TO: Madeleine Reinke, Kimley-Horn and Associates, Inc.
FROM: Cynthia Thye, Planner 1
DATE: March 19, 2026
SUBJECT: SP25-119: Lincoln Professional Park L2 - 7 Brews Coffee – Site Plan
Review Comments 03

Description: Lincoln Professional Park L2 - 7 Brews Coffee

1 SITE PHOTOMETRICS
SE1.1 1" = 20'-0"

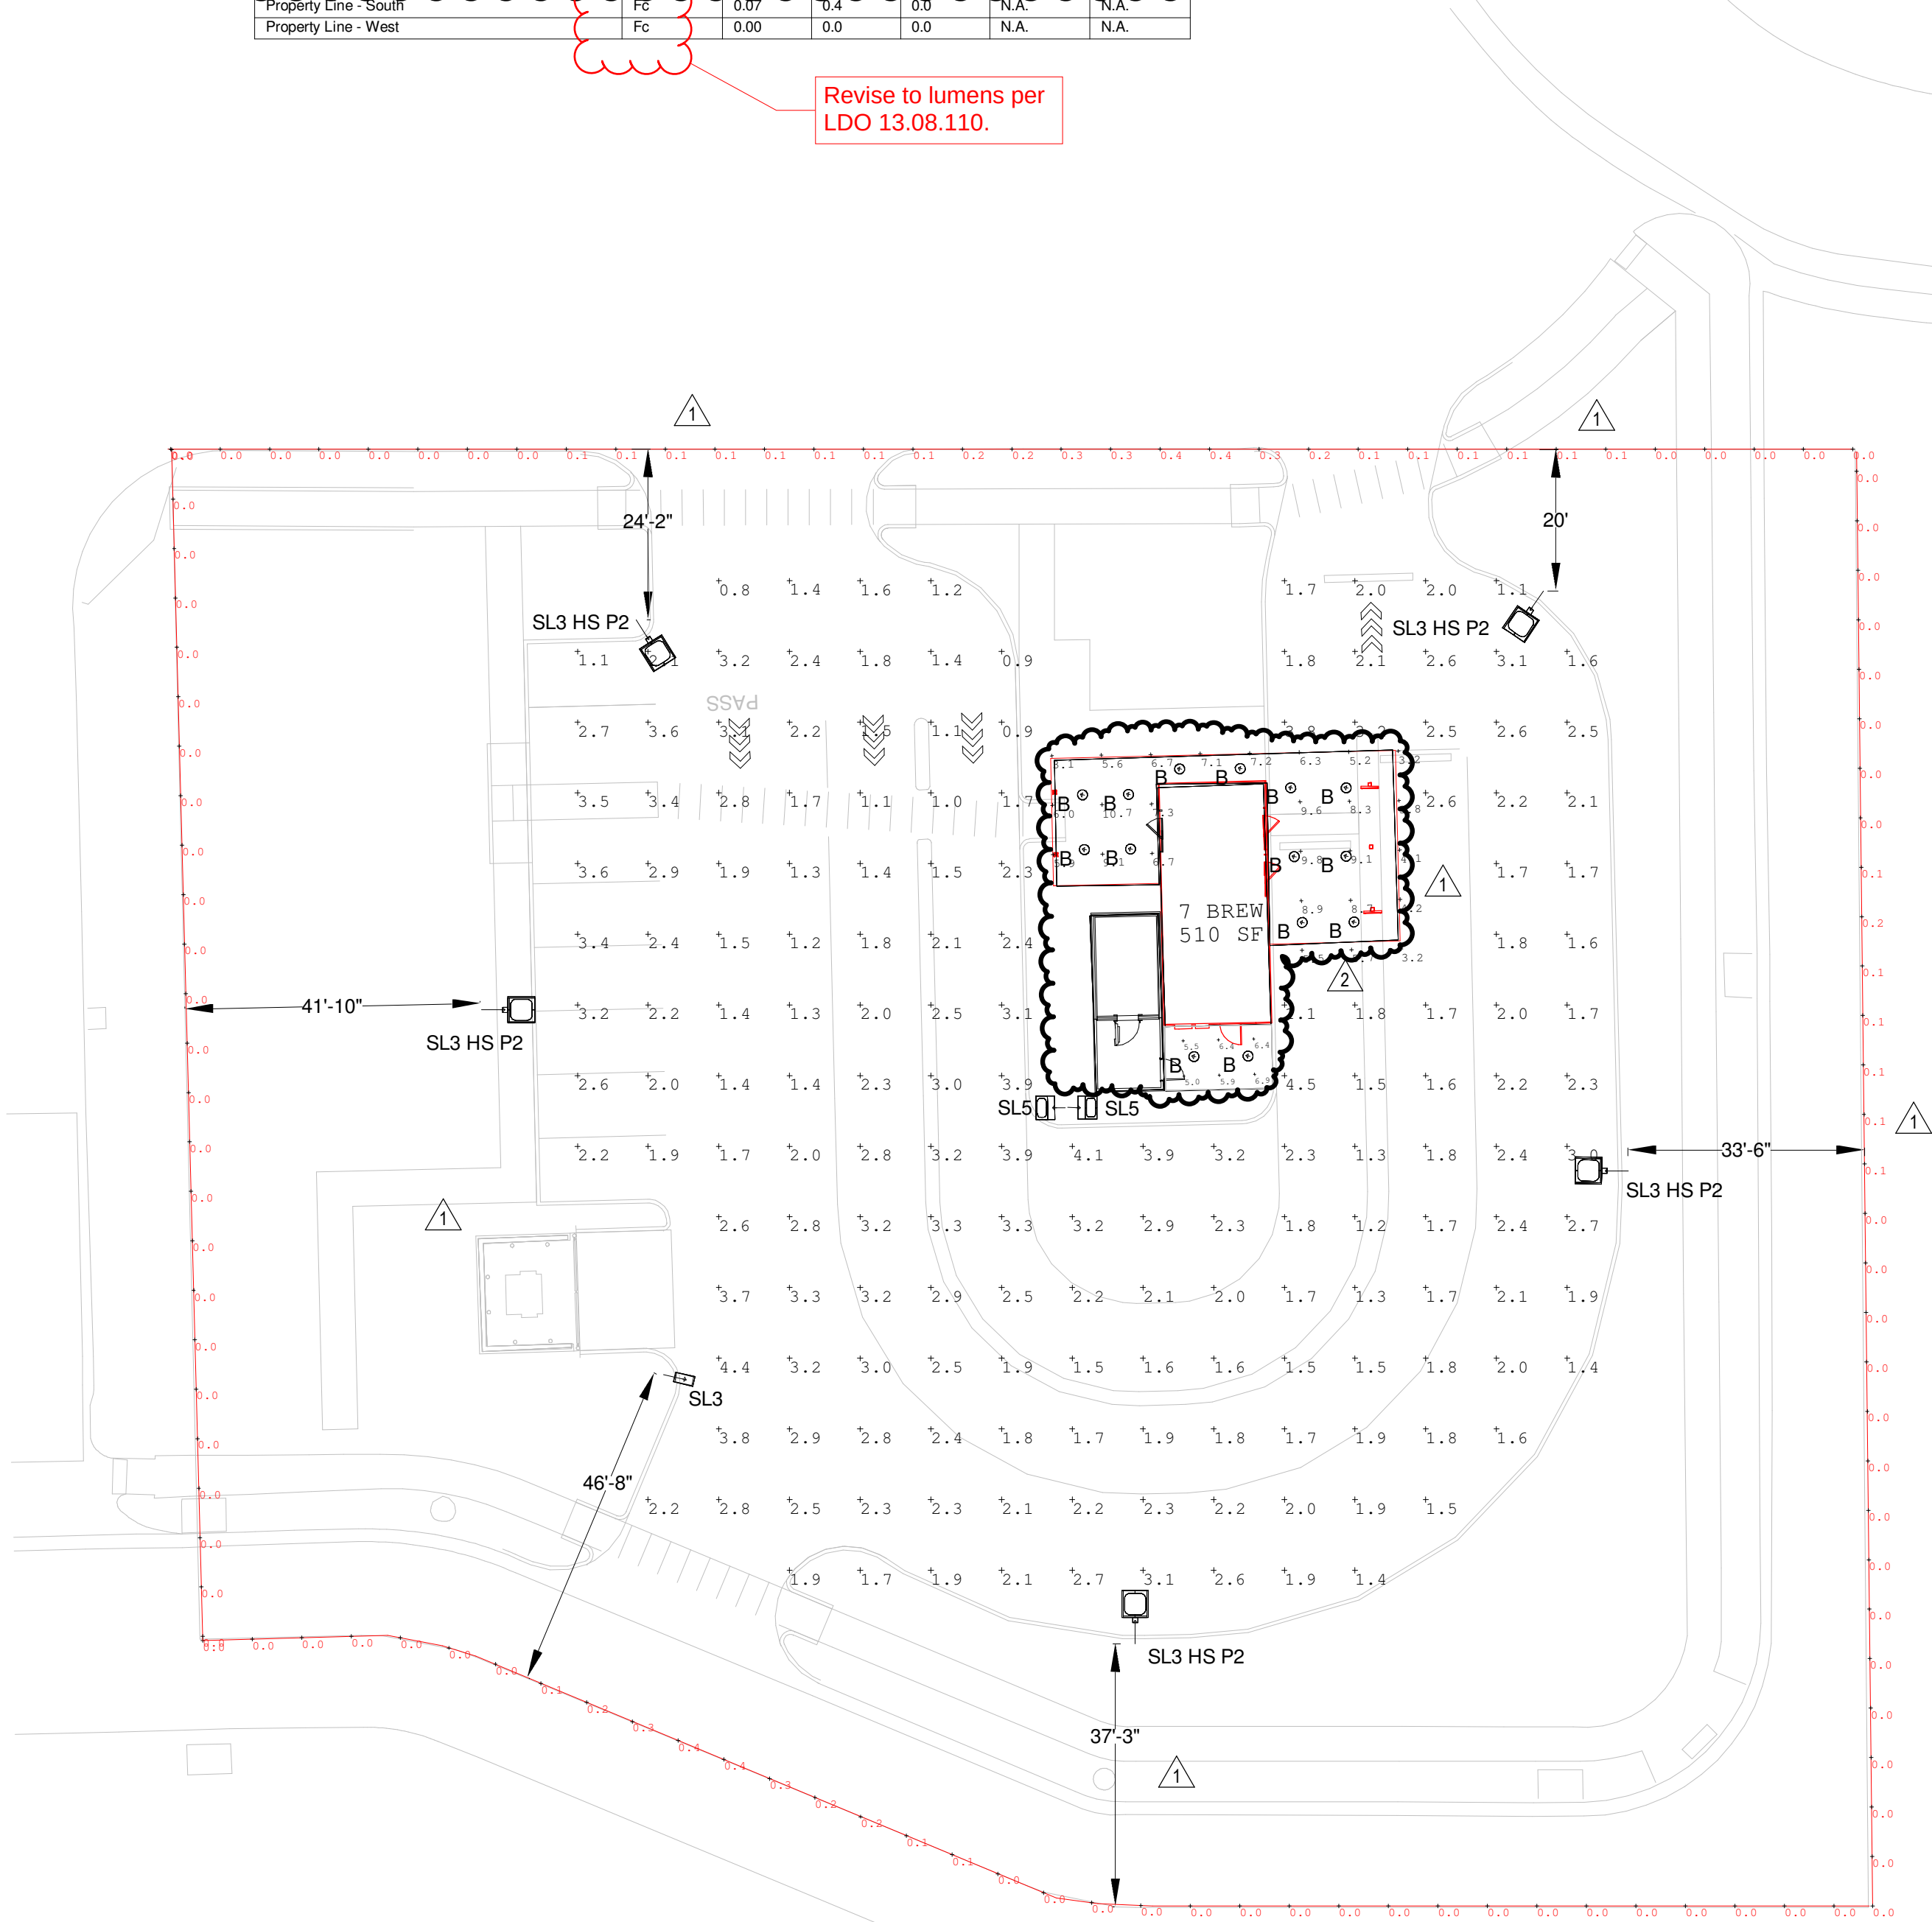
1. Revise Calculation Summary Table to show lumens not foot candles per LDO 13.08.110.

Revise to lumens per LDO 13.08.110.
